Village of Arlington Heights
Conceptual Plan Review Committee
Community Room, 3rd Floor
Arlington Heights Village Hall, 33 S. Arlington Heights Rd.
April 11, 2024
6:30 PM

Item: The Berkshire Senior Living Residence - 8-12 S. Beverly Ln. - T1838

**VILLAGE OF ARLINGTON HEIGHTS
STAFF DEVELOPMENT
COMMITTEE REPORT**

Temp File Number: T1838
Project Title: The Berkshire Senior Living Residence
Address: 8-12 S. Beverly Lane
PIN: 03-29-411-014

CONCEPT | PROPOSED PARKING GARAGE PLAN

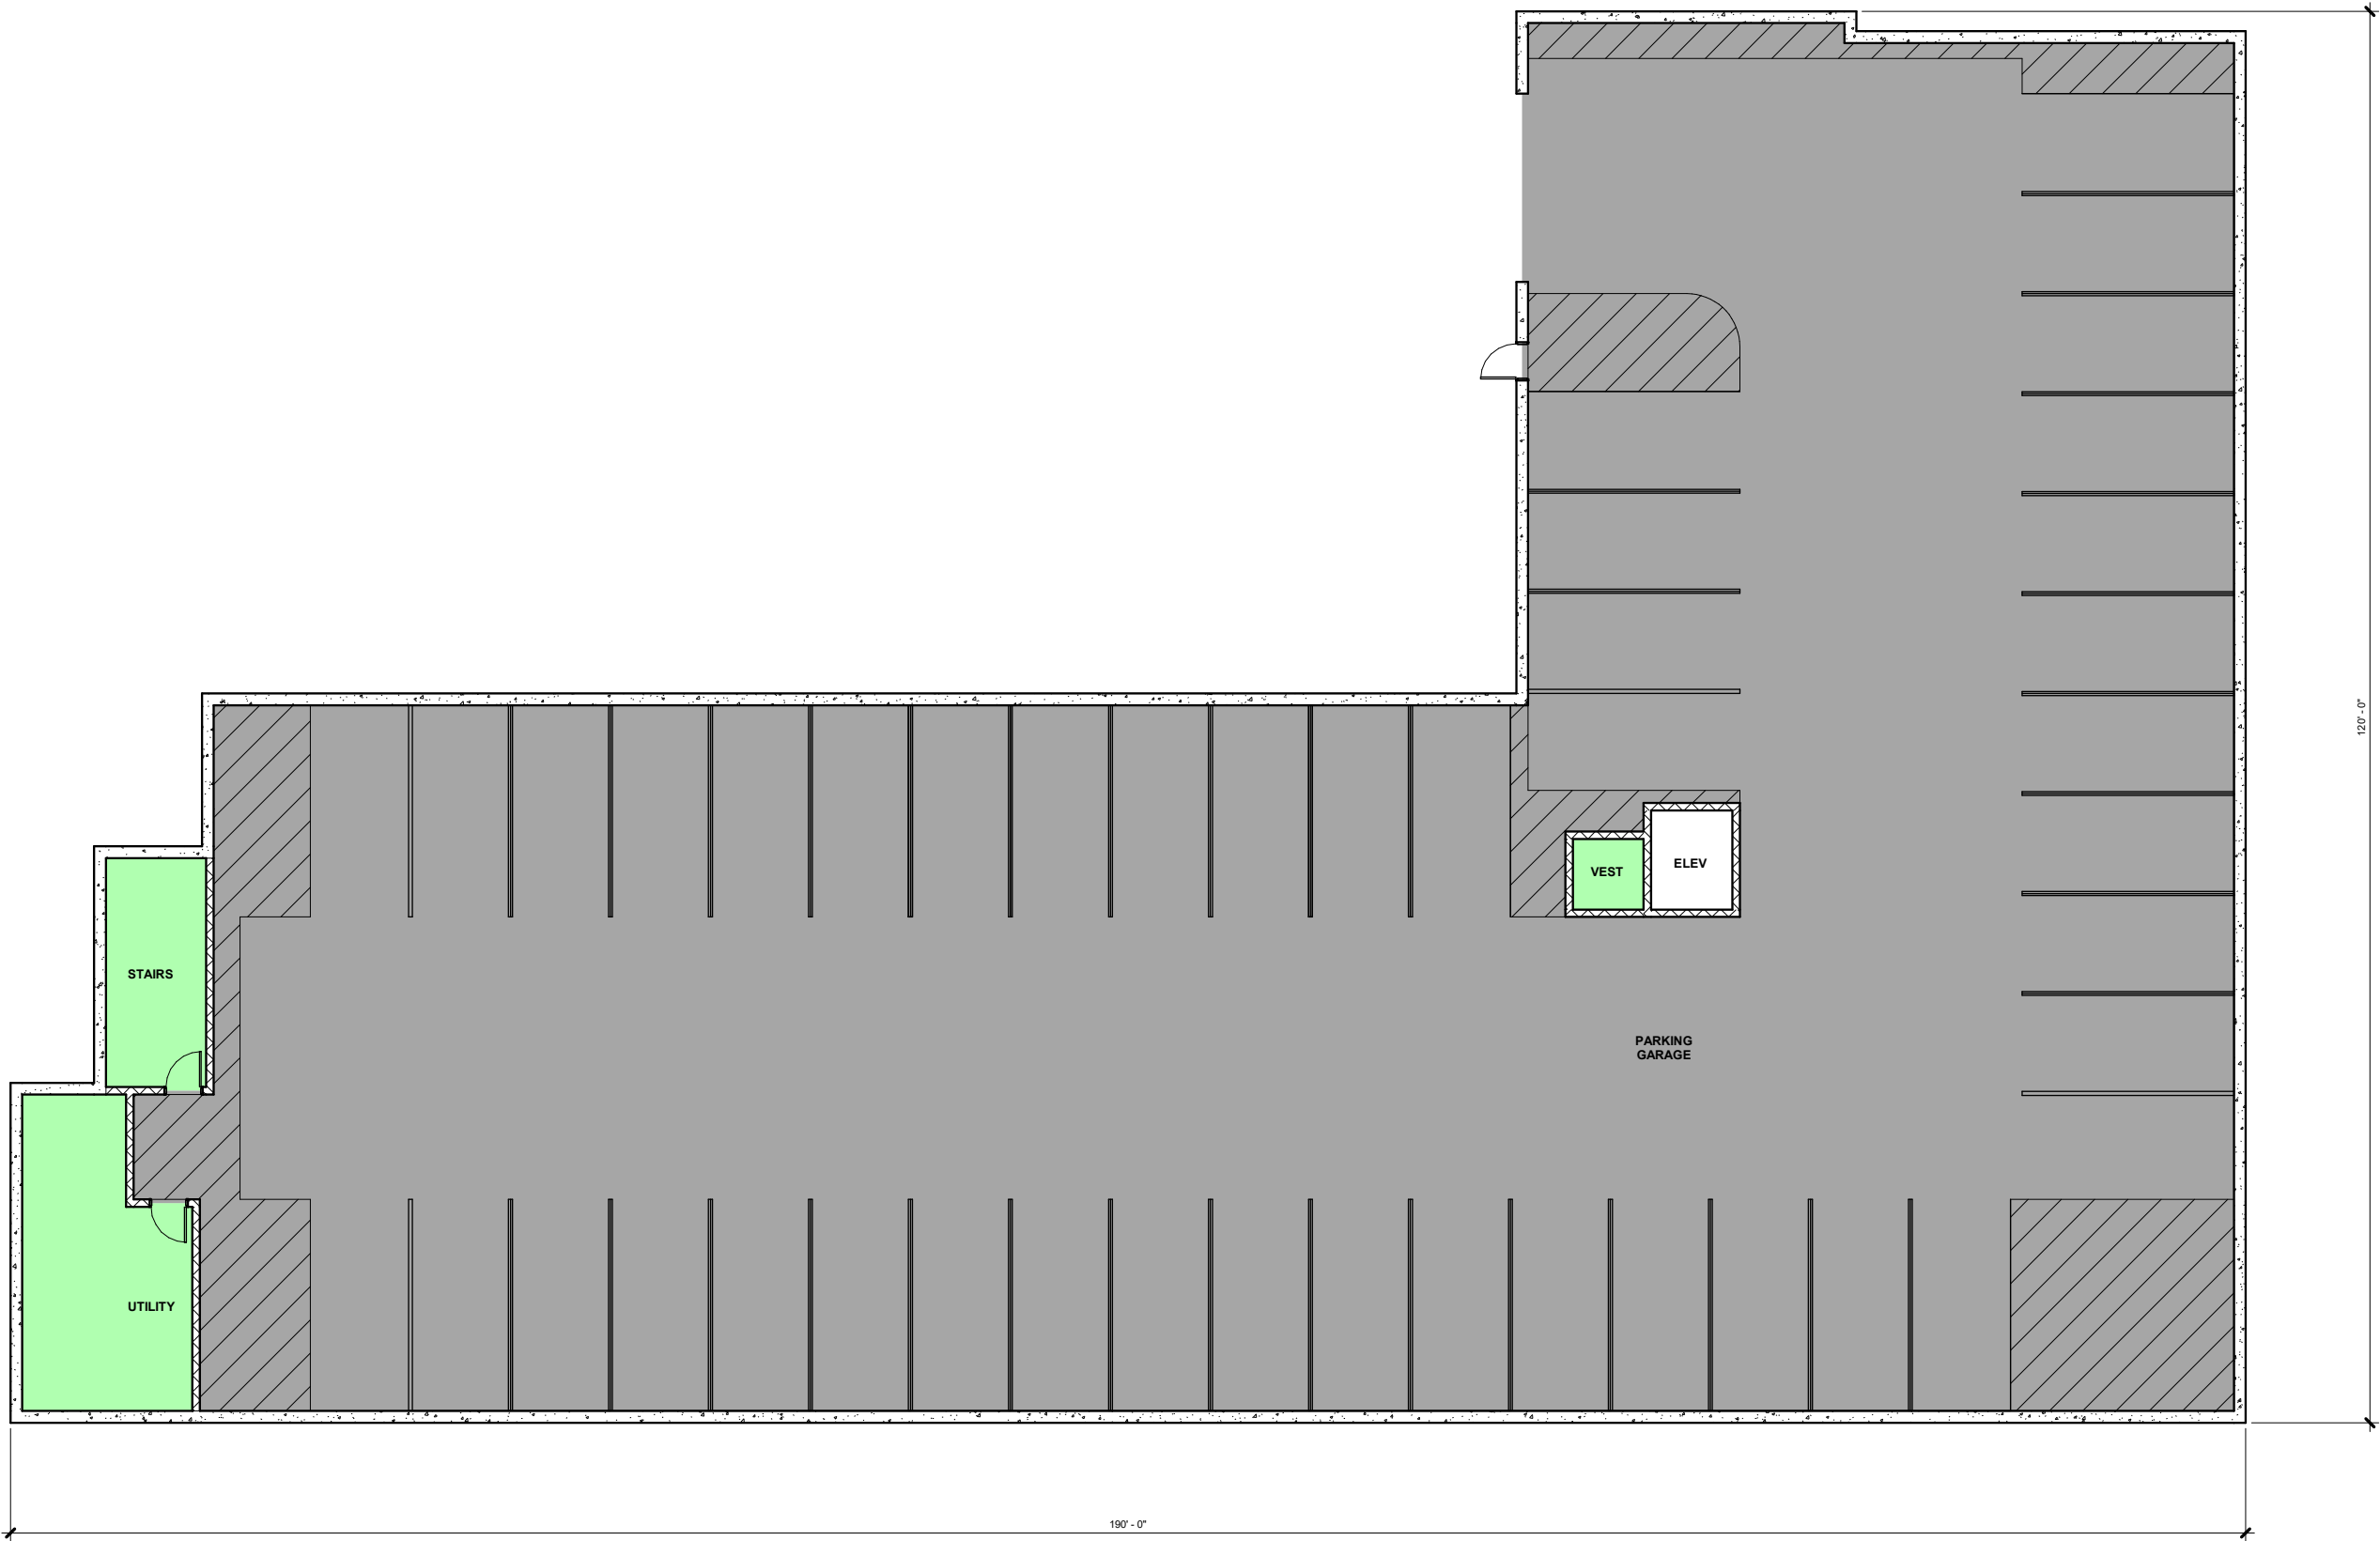
One 10' x 35' loading space for the development is required, and none is shown on the conceptual plans. The petitioner will need to clarify if they are requesting a variation to waive this requirement.
